PLANNING COMMISSION AGENDA

SUBJECT: American 1 Credit Union Site Plan

SITE DEVELOPMENT PLANS
JANUARY 20, 2023

SUBJECT: The Millhaven Site Plan

SITE PLAN

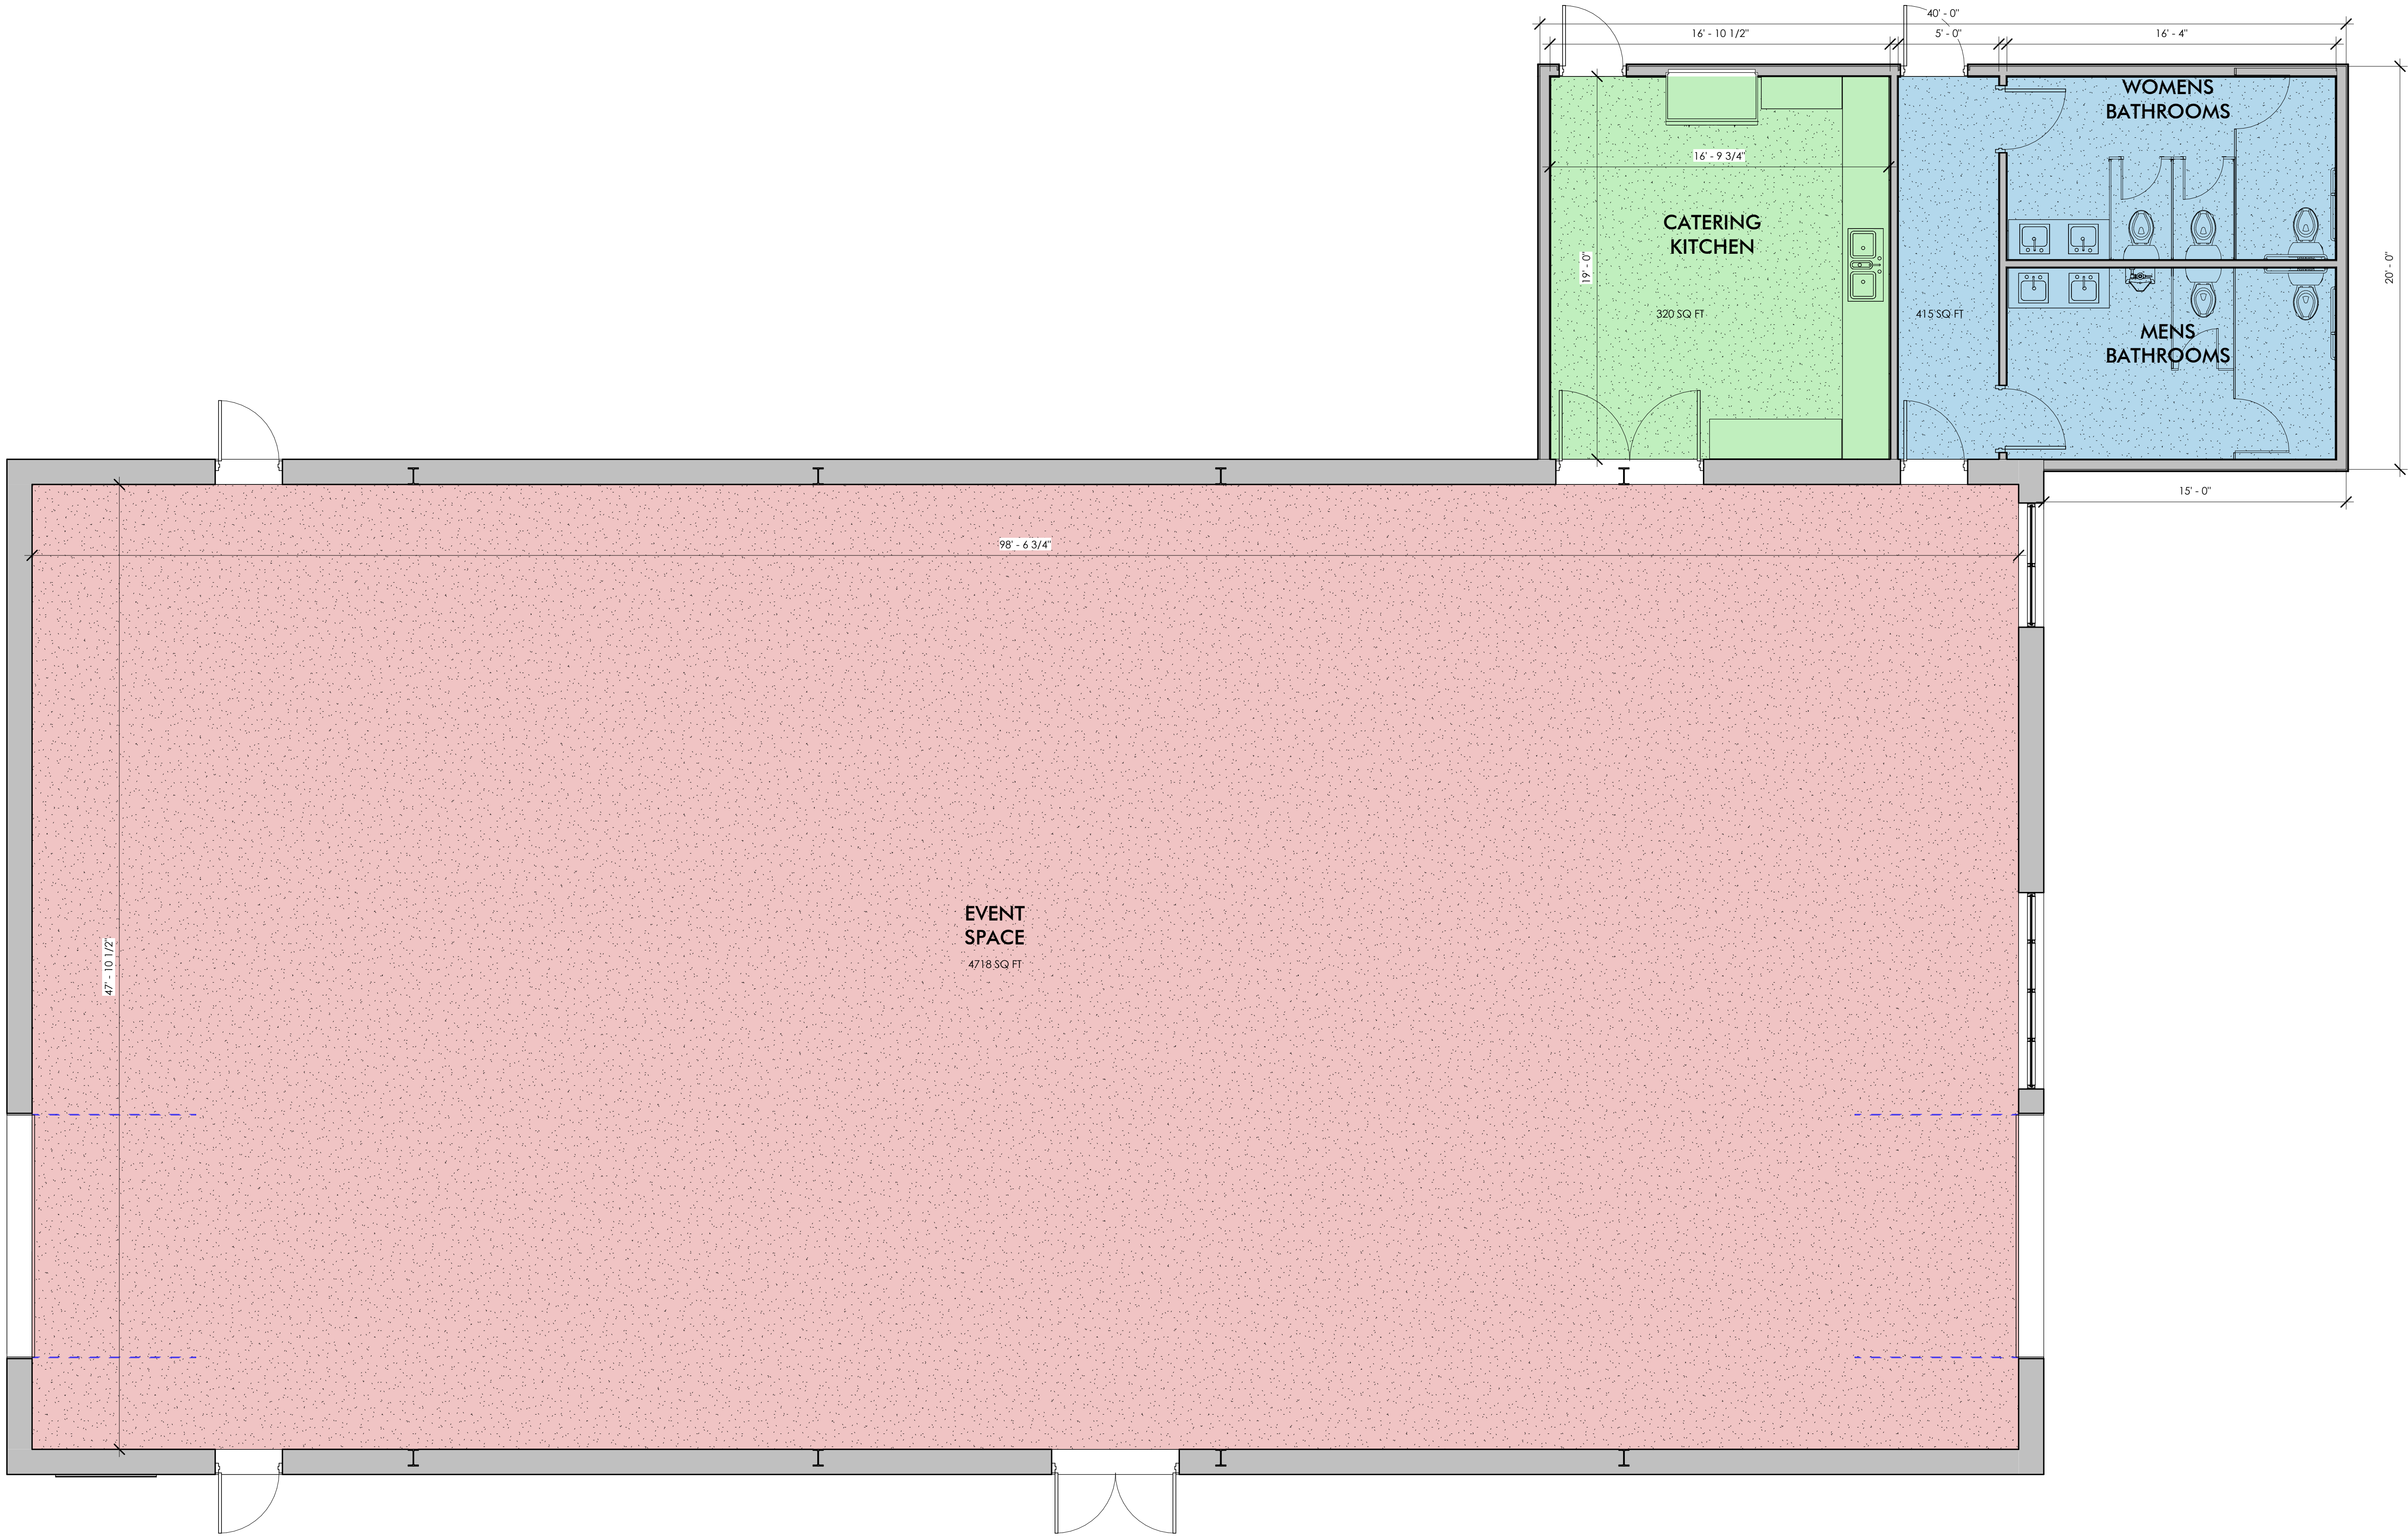
The proposed use of the space requires 112 parking spaces, with five required to meet ADA Barrier-free requirements. This requirement will be met through the addition of five spots on the property, the use of the County parking lot, and the parking lot at 317 South Grand Street. The zoning ordinance allows for the collective use of parking in this manner. An agreement with the county and the lease for the grand street property are in the process of being submitted for our files. If either property is not available in the future, parking will need to be added on the property.

4. Please show sidewalks to venue entrance(s) on site plan.
5. Installation of 4" fire suppression line must be coordinated with the Water Department.
6. Storm Sewer review is under review by Public Services Dept. Roof storm drain and parking lot runoff must be contained on site.

7. Trash container was not identified on the site plan. This information needs to be provided and must meet the Zoning ordinance and other city ordinances.

8. Electrical needs for new facility must be communicated with City Electric Department as soon as possible.
9. Sidewalk installation along West Spruce is required by ordinance. Request a waiver from planning commission if owner does not want to install.
